RE: Mesa Del Sol Montage Unit 3B
Revised Grading Plan Stamp Date: 6/6/19 (Sheets 1 & 5)
Grading Plan Stamp Date: 2/15/19
Drainage Report Stamp Date: 1/18/19
Hydrology File: R16D006

RE: Mesa Del Sol Montage Unit 3B
Grading Plan Stamp Date: 2/15/19
Drainage Report Stamp Date: 1/18/19
Hydrology File: R16D006

Re: Project No 775782: Mesa Del Sol, Montage Unit 3B - Re-Submittal
-Drainage Report for Mesa del Sol Residential Montage Unit 3 and 4 (Prior Stamp Date:
4/25/2014) New Stamp Date 01/18/2019
-Grading & Drainage Plan (Prior Stamp Date 8/29/2018) New Stamp Date 01/18/2019

GRADING AND EROSION CONTROL PLAN DETAILS		Mo./Day/Yr.	
Design Review Committee	City Engineer Approval		
Last Design Update			
City Project No.	Zone Map No.	Sheet	Of
775782	R-15,16 S-15,16	6	7

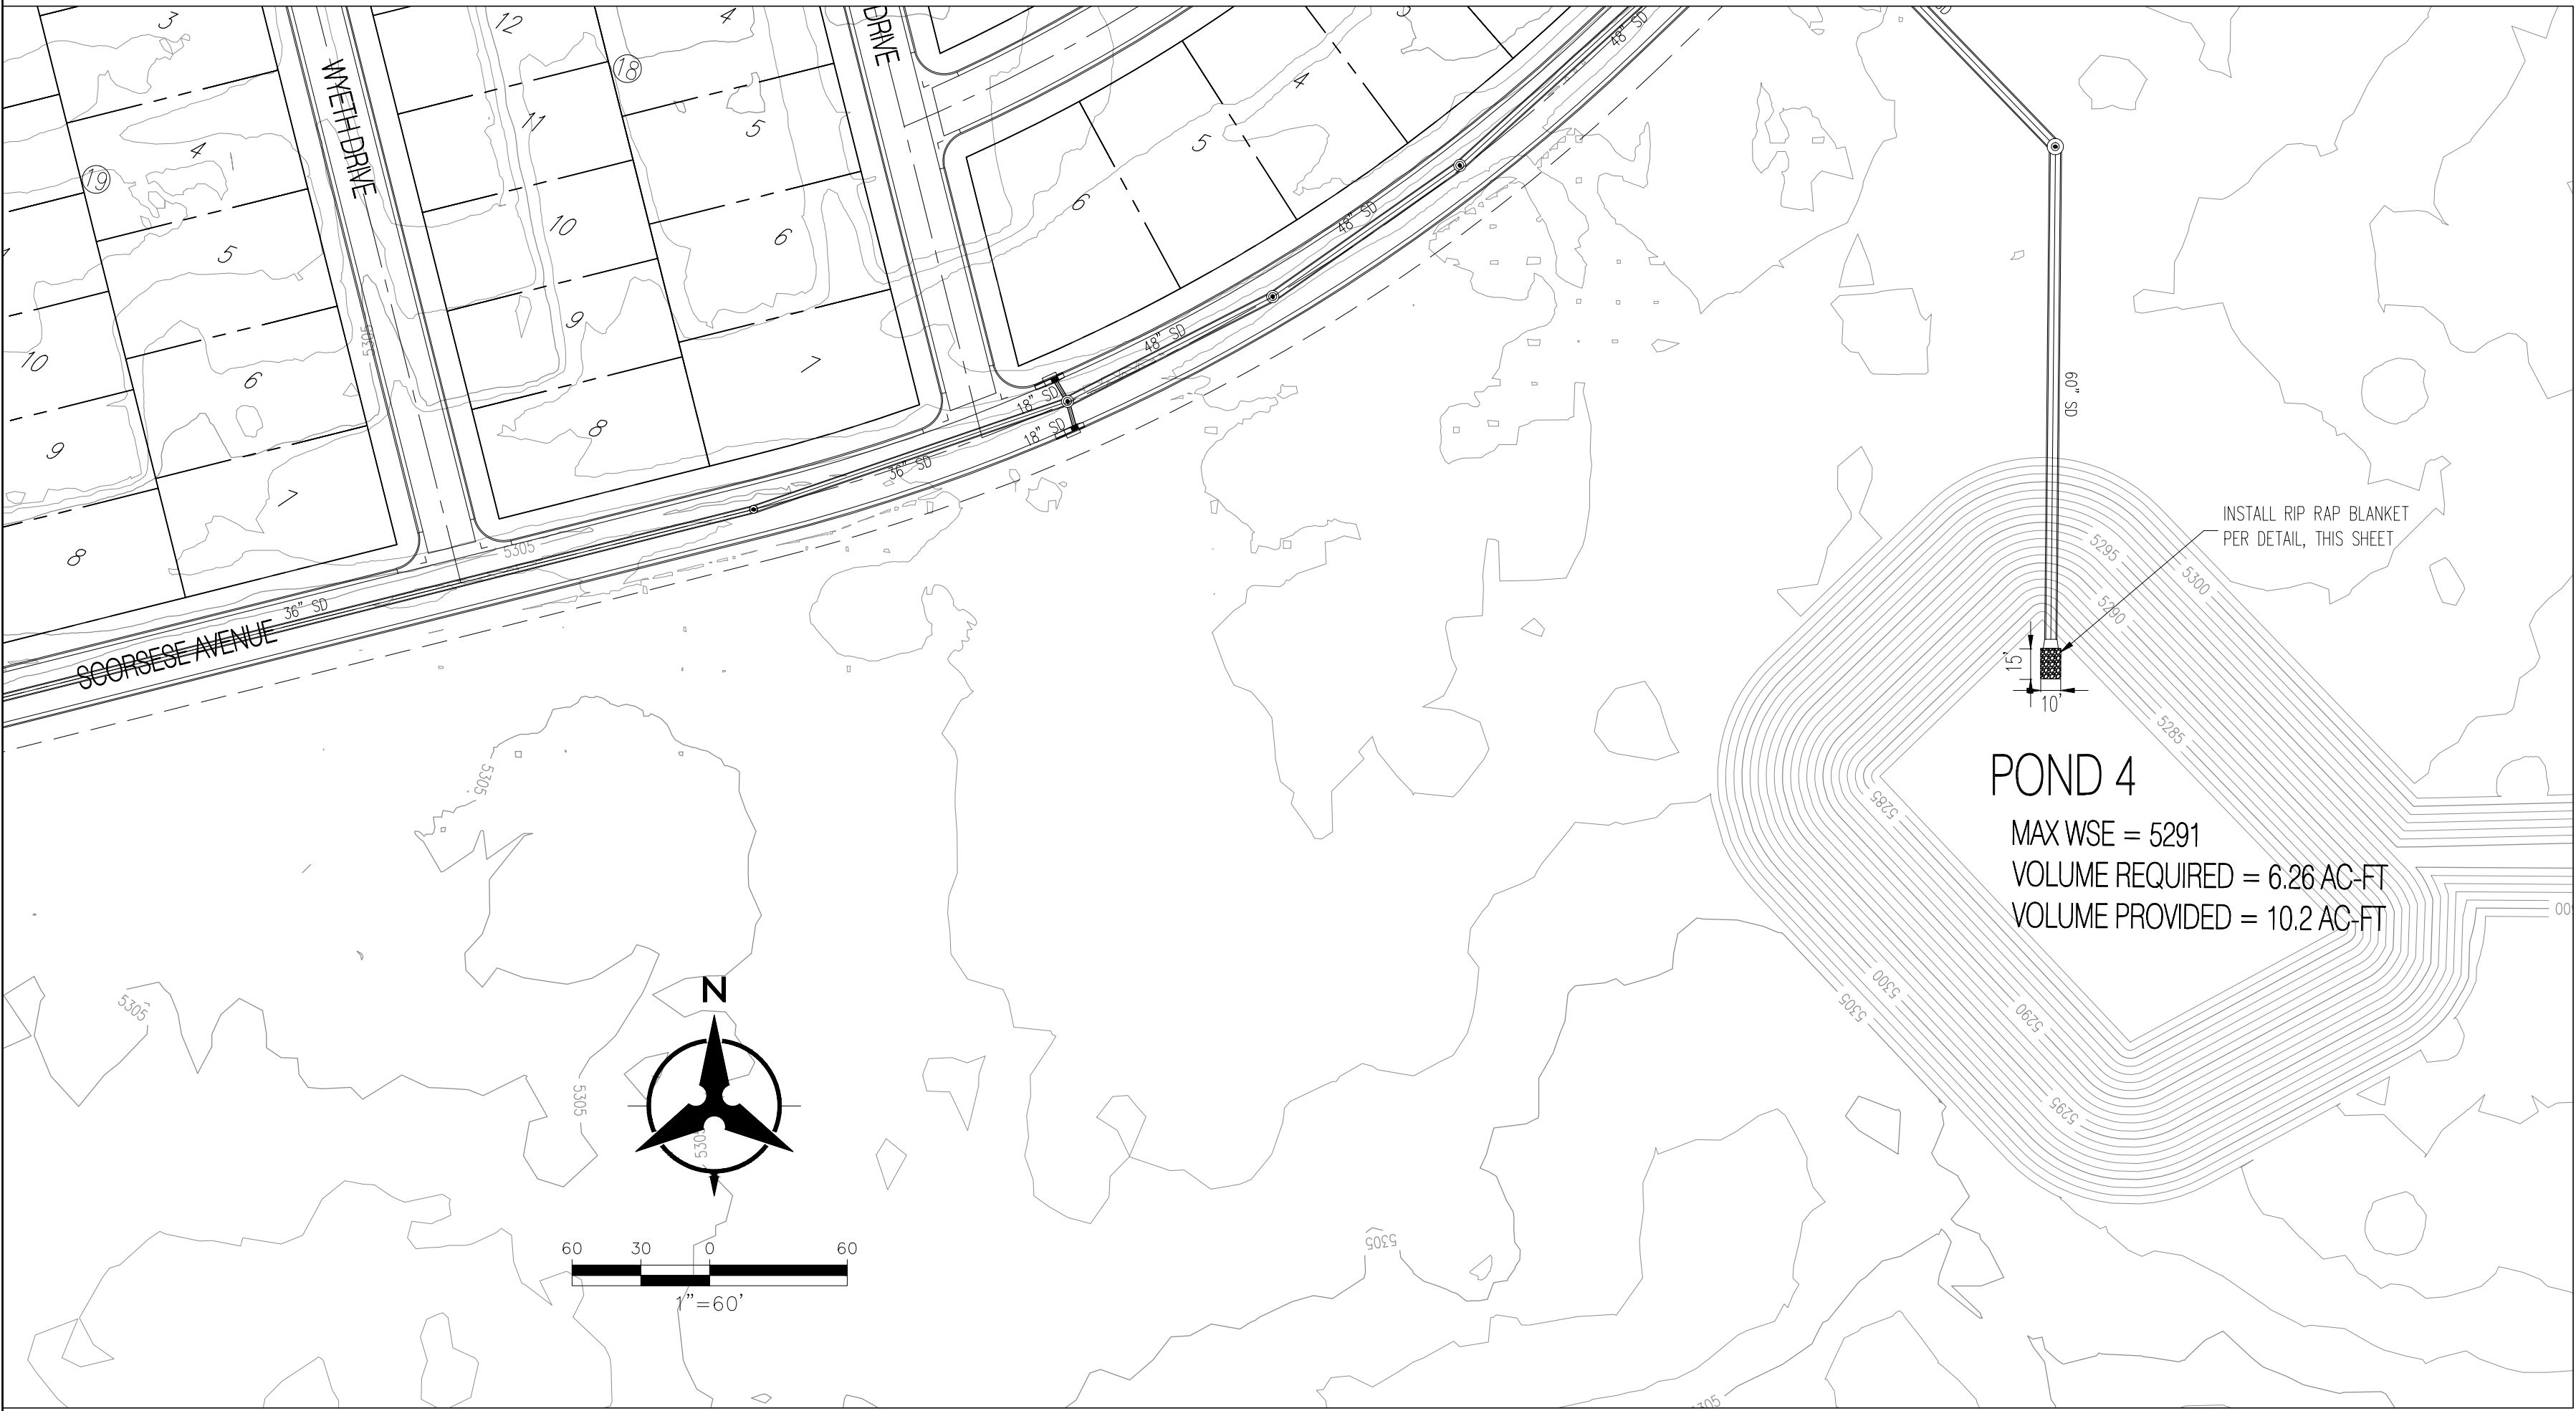
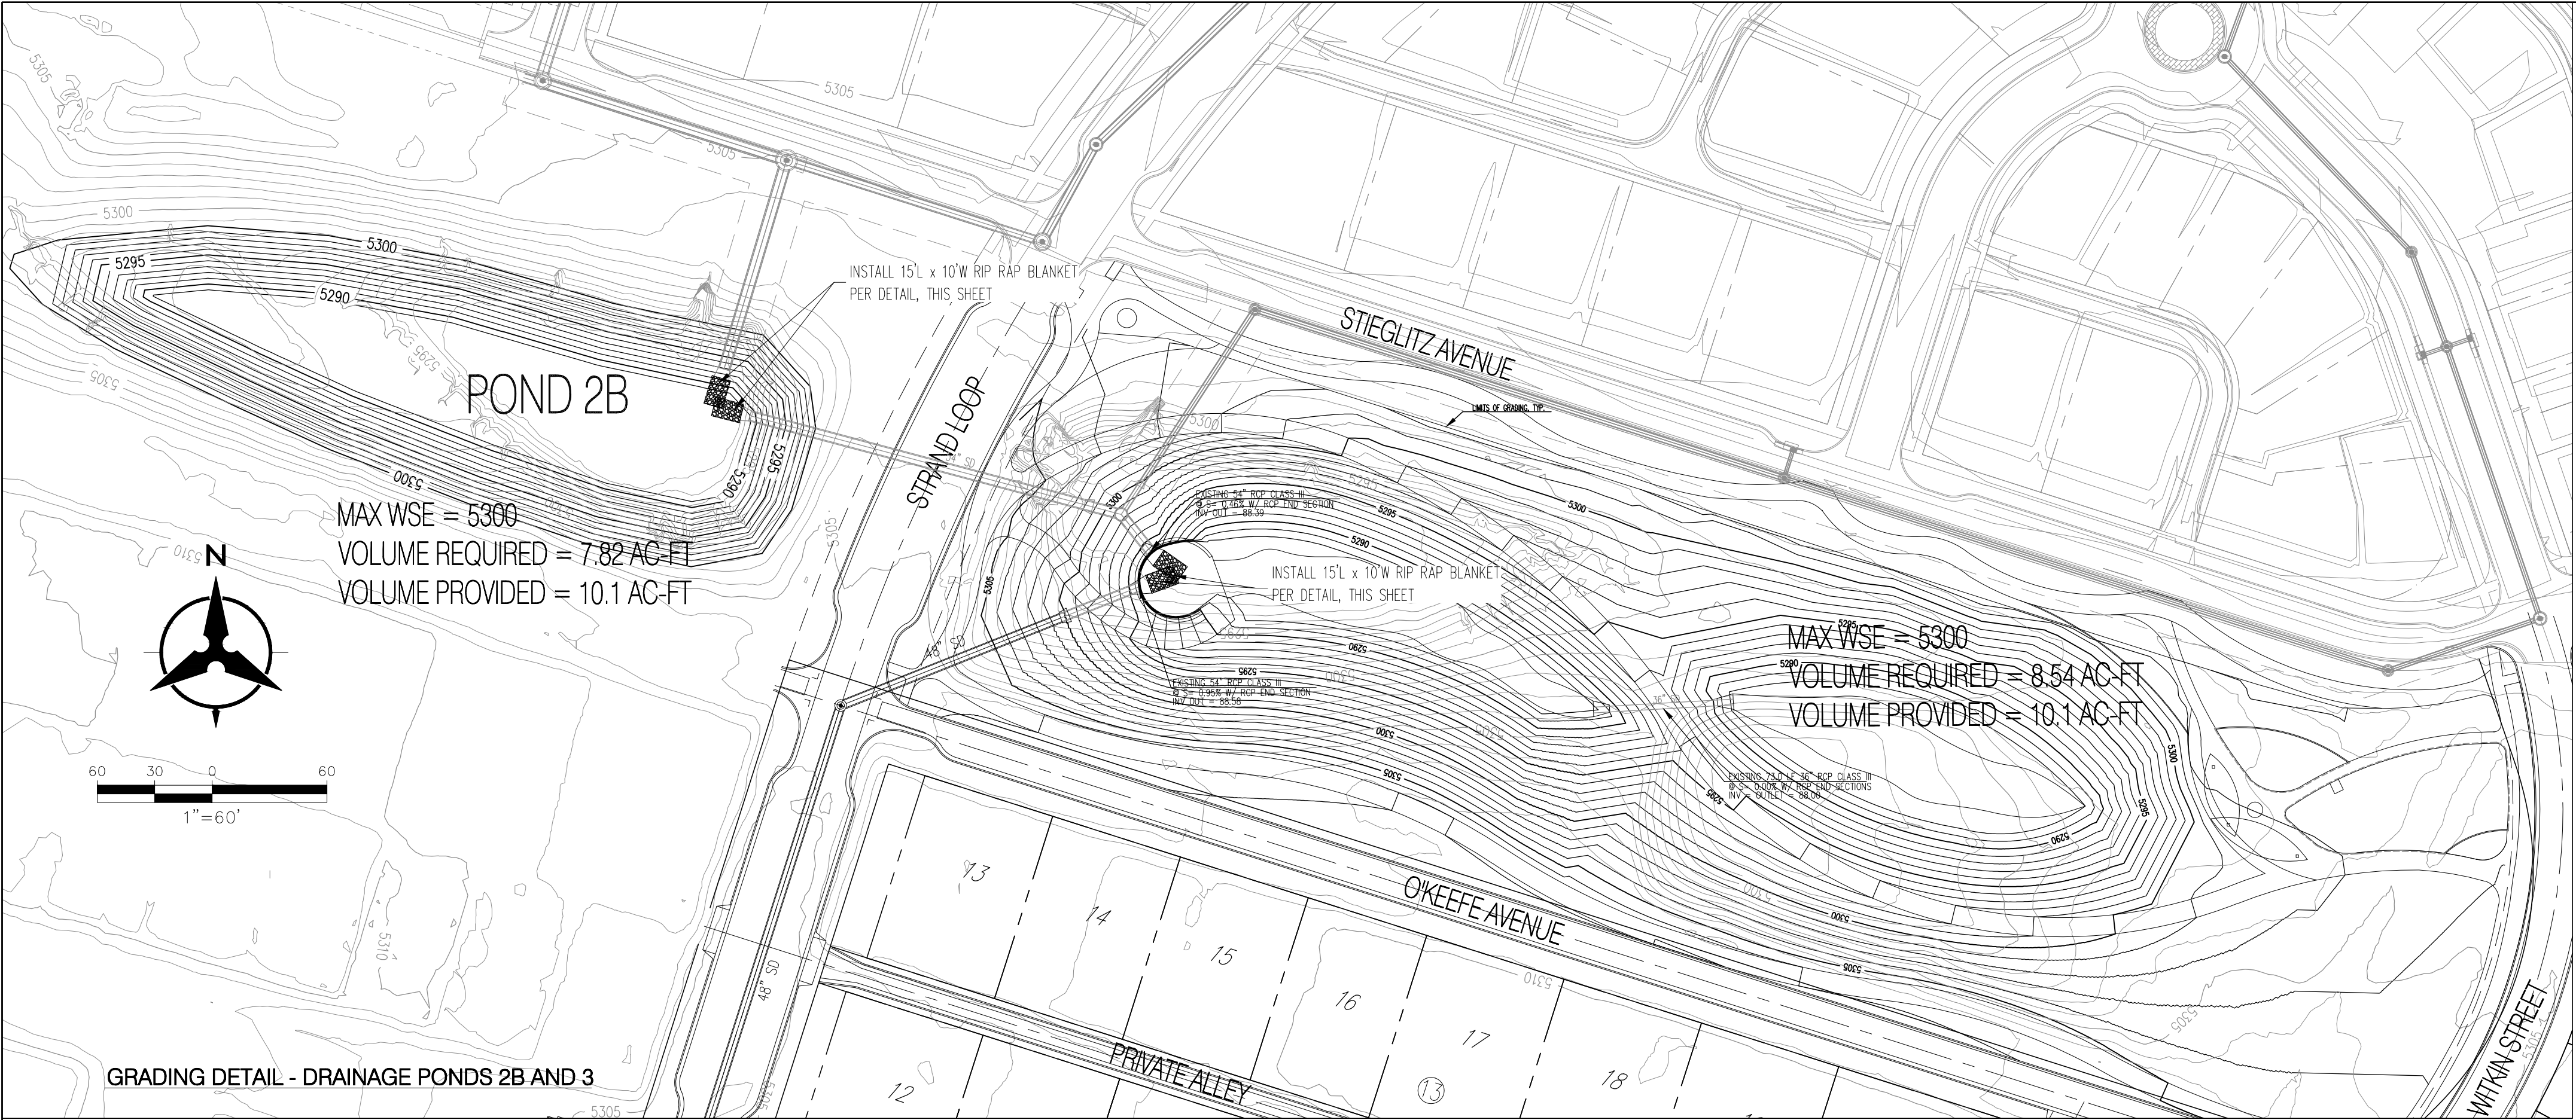
6. Show typical sections at the walls showing both the interim grading that will be certified on the Engineer's Certification after the developer's work is complete and the future grading that will occur after the walls are built by the home builder. The typical sections should show the property lines and horizontal and vertical dimensions (maximum and minimum). See Revised Grading Plan – Sheet 7 of 7.

8. Add typical sections at walls, both retaining and garden walls, where they are next to right of ways showing that the footer does not encroach into the right of way. Added to the Revised Grading Plan on Sheet 7 of 7
